**Enclosure 3 to E-54837**

**RAI Responses with associated application  
change pages**

**Environmental Requests for Additional Information****Proposed Action (PA)****RAI PA-1**

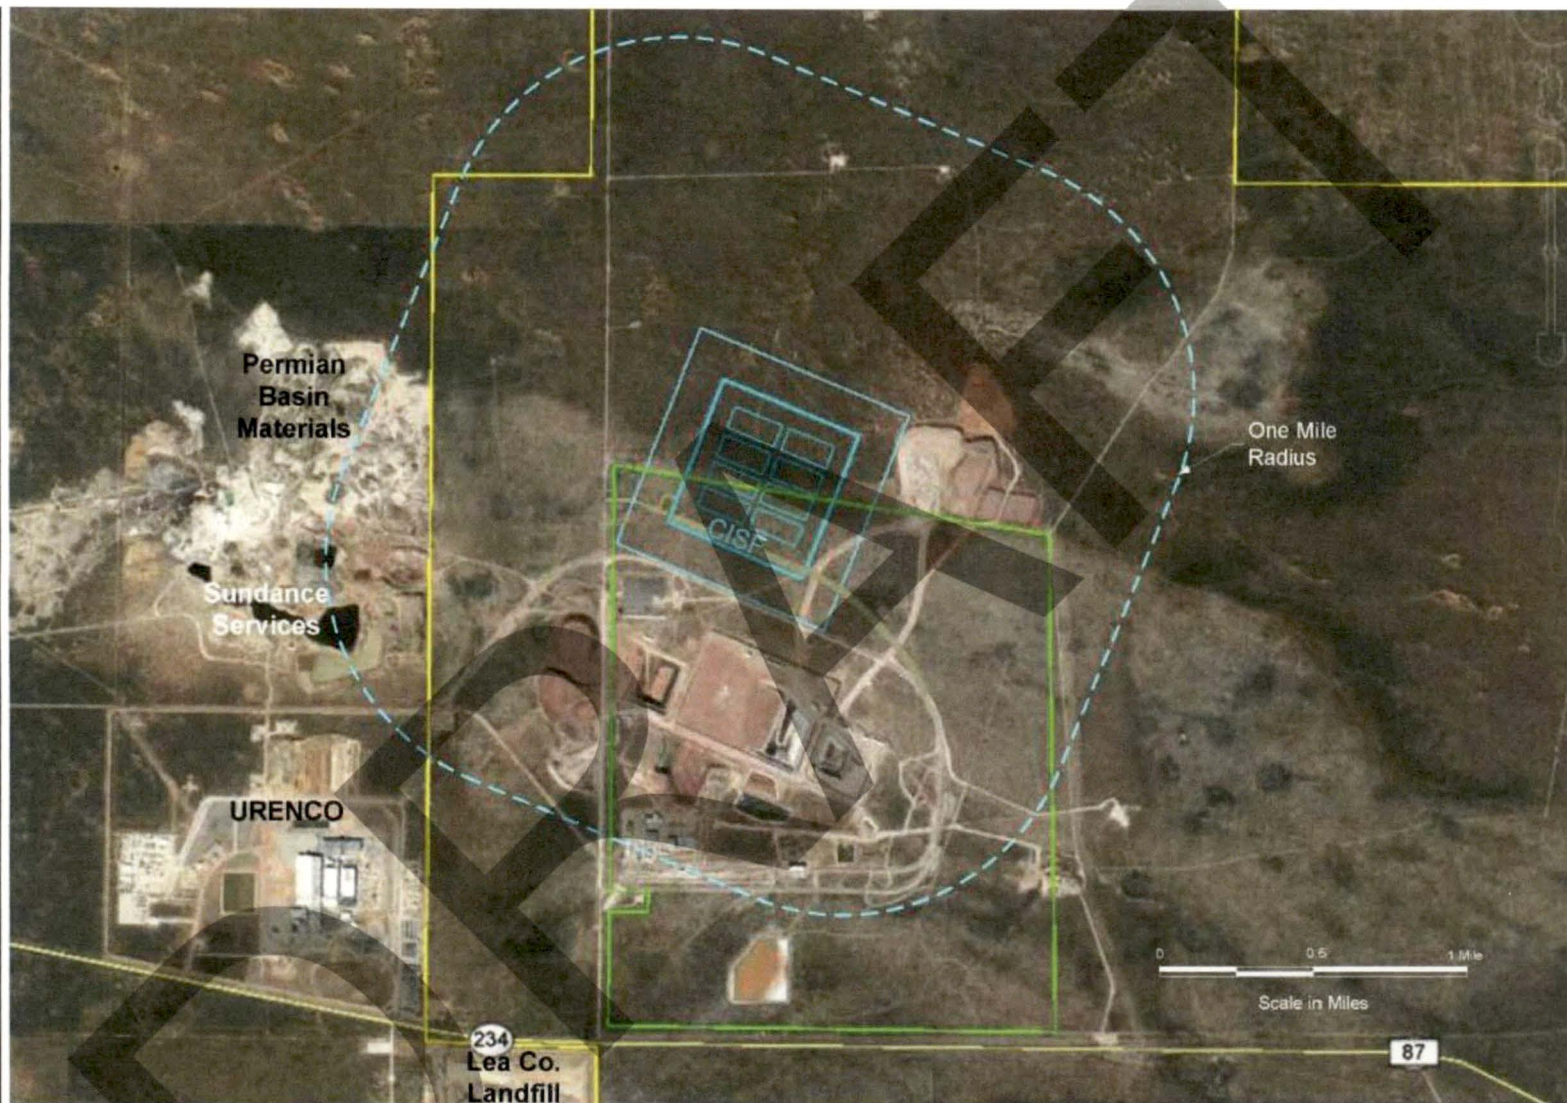
- Clarification of the location (i.e., footprint) of the railroad side track. The location of the proposed railroad side track is not consistently depicted in figures in the Environmental Report (ER). For example, compare ER Figure 2.2-6 with ER Figure 4.5-1. Specifically, clarify whether the railroad side track would cross Stateline Road into New Mexico as depicted in ER Figure 4.5-1.

- New Mexico (as depicted in ER Figure 4.5-1, the railroad side track appears to be partly located in both states).
- A description of the materials, methods, and equipment that would be used to construct, operate, and maintain the railroad side track, including timing of the construction. If the side track would be decommissioned along with the CISF, include similar information for decommissioning.

- The railroad side track will be limited to Texas and will not cross stateline road into New Mexico. ER Figure 2.2-6 and the identical Figures 3.2-4 and 4.5-1 have been updated to be consistent with the side track layout. Additional figures have been updated to be consistent with the change. The affected figures are: ER Figures 2.2-6, 3.1-3, 3.2-4, 3.3-1, 3.6-1, 4.2-1 (deleted), 4.5-1, 4.12-1, 4.12-7, 4.12-8, 4.12-9, 4.12-10, 4.12-11, and 4.12-12 as well as SAR Figures 1-1, 1-2, 1-3, 2-1, 2-4, 2-15, 9-1, 9-2, and 9-6.

ISP would construct a rail sidetrack, approximately 2 km (1.25 mi) in length, from the existing rail spur leading into the *Cask Handling Building* at the CISF (Figure 3.2-4).

Figure 3.3-1  
Location of Cross-Sections

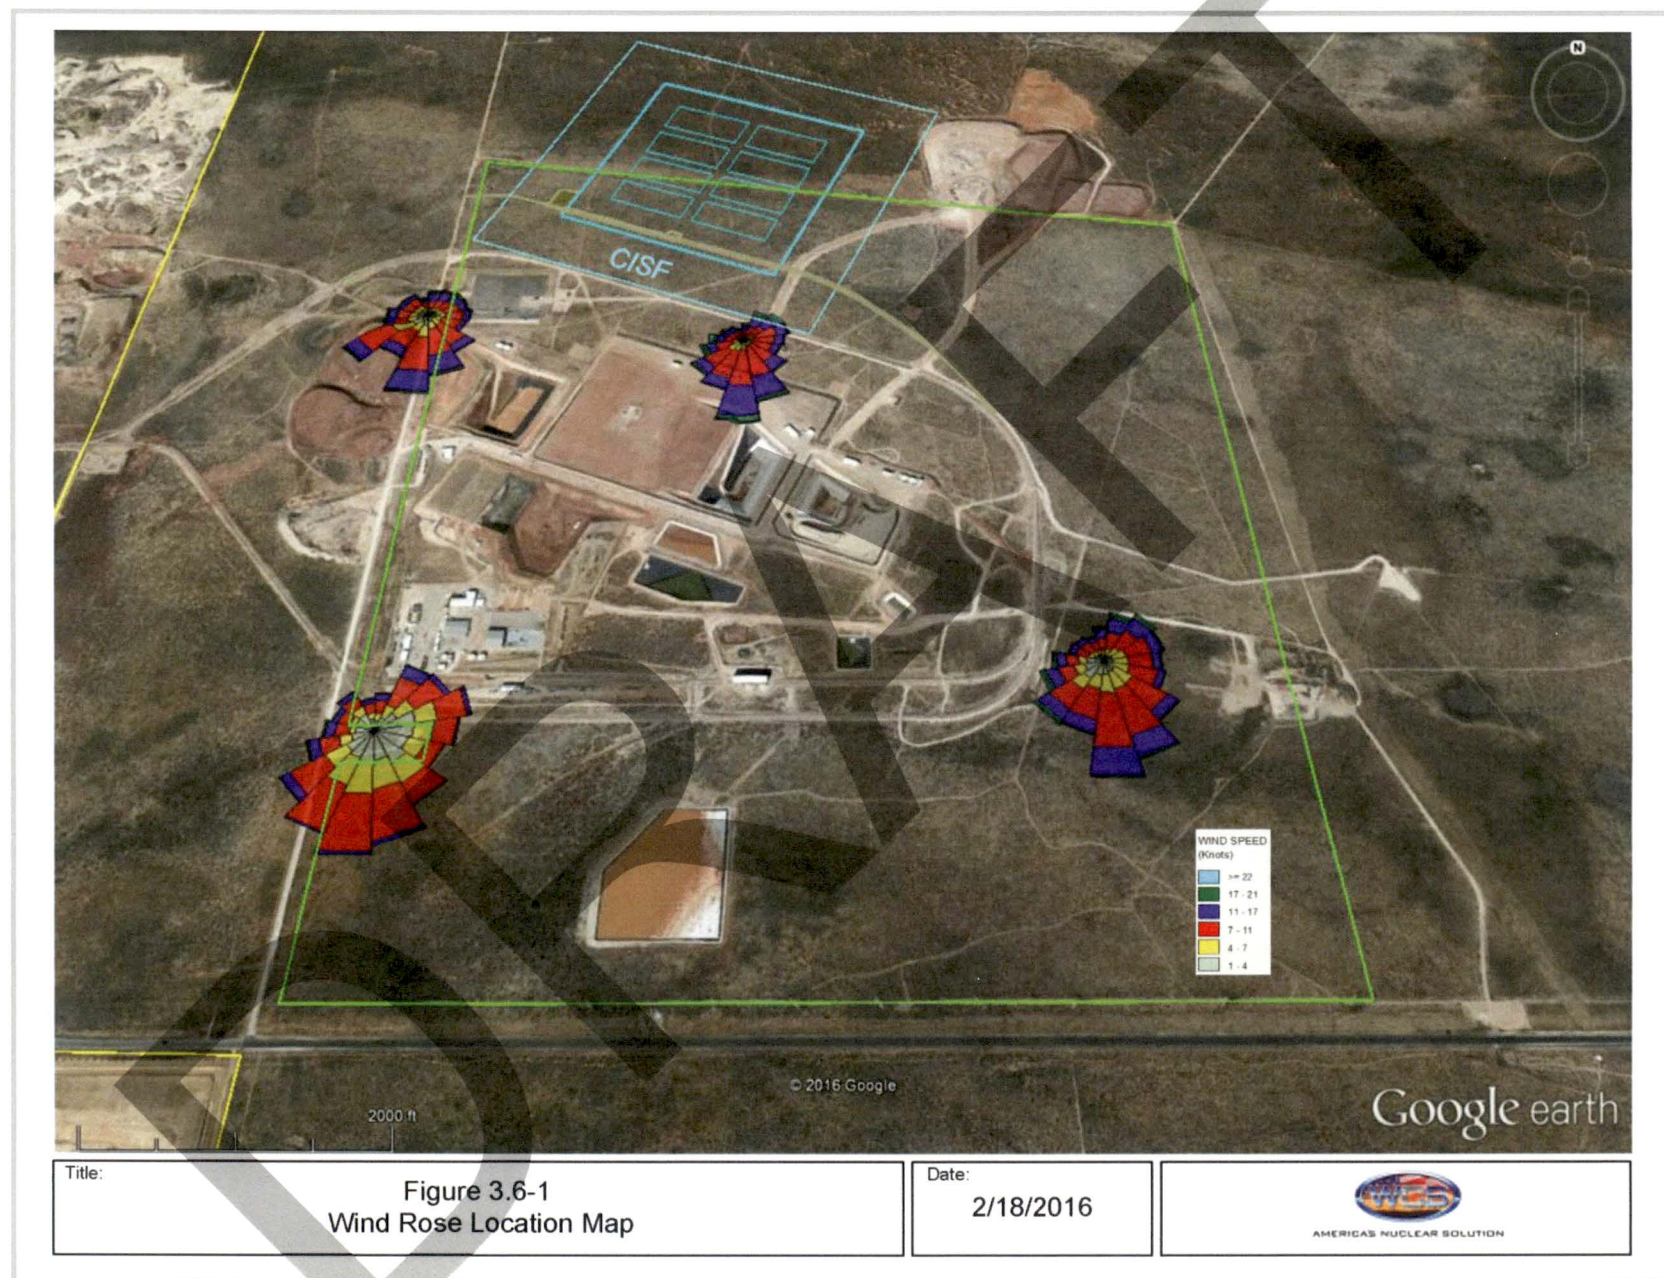
**Provide additional information on the railroad side track to be built as part of the proposed CISF. This information should include:**

**Figure 2-16**  
**WCS CISF Cross Section West-East**

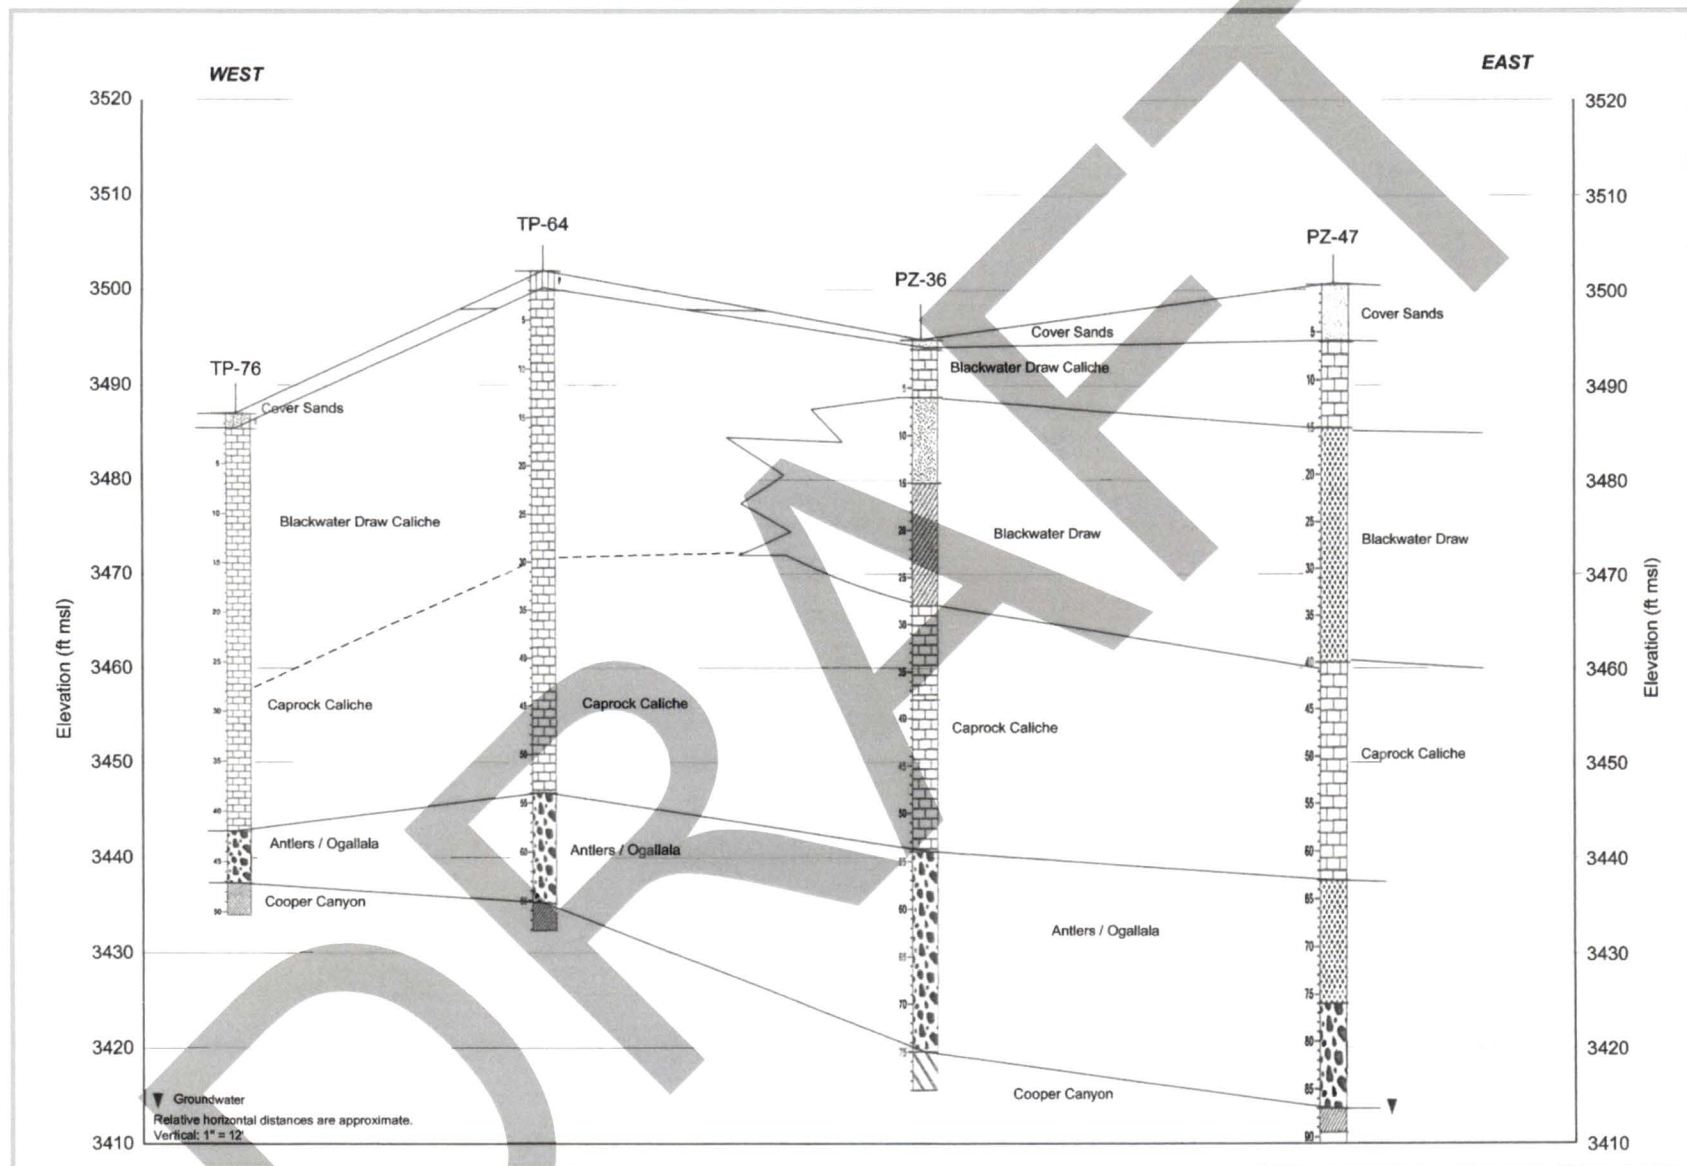
**Provide geologic formation names instead of generic material labels on updates to SAR Figures 2-16 and 2-17 (i.e., geologic cross-sections). The affected groundwater environment must be clearly described.**

*The CISF is located at or near a surface water/groundwater basin divide, where three near-surface geologic units have discrete interfaces within relatively short distances (i.e., Ogallala Formation, Antlers Formation, and Gatuña Formation). For the adjacent LLRW site, Lehman and Rainwater (2000) clearly indicated what units lay beneath the proposed facility. In contrast, SAR Figures 2-16 and 2-17 only provide generic material type labels on the geologic cross-sections for the proposed CISF, and are, therefore, not explicit about which formations underlie the proposed facility. The proposed CISF would be located above regionally extensive, formally named geologic units having characteristics that are well-described in the literature. Additional information is needed about which hydrogeologic formations underlie the CISF site to accurately describe the affected groundwater and vadose zone environments at the proposed CISF and support assessment of the potential environmental impacts of CISF construction, operation, and decommissioning.*

SAR Figures 2-16 and 2-17 and ER Figures 3.3-2 and 3.3-3 have been updated to include the geologic units as opposed to the generic material labels and the location of any groundwater encountered. The geologic formation names correlate with the site-specific stratigraphic column found as Figure 2-37 in the SAR. All of the boreholes were dry when drilled with the exception of PZ-57 and PZ-47 and the monitoring wells installed in the boreholes are dry with the exception of PZ-57 and PZ-47, which are located north of the Protected Area for the proposed CISF. SAR Figures 2-16 and 2-17 have been updated to include the level of groundwater located in the monitoring wells PZ-57 and PZ-47. See RAI Response WR-5 for more information regarding the groundwater environment underlying the site.
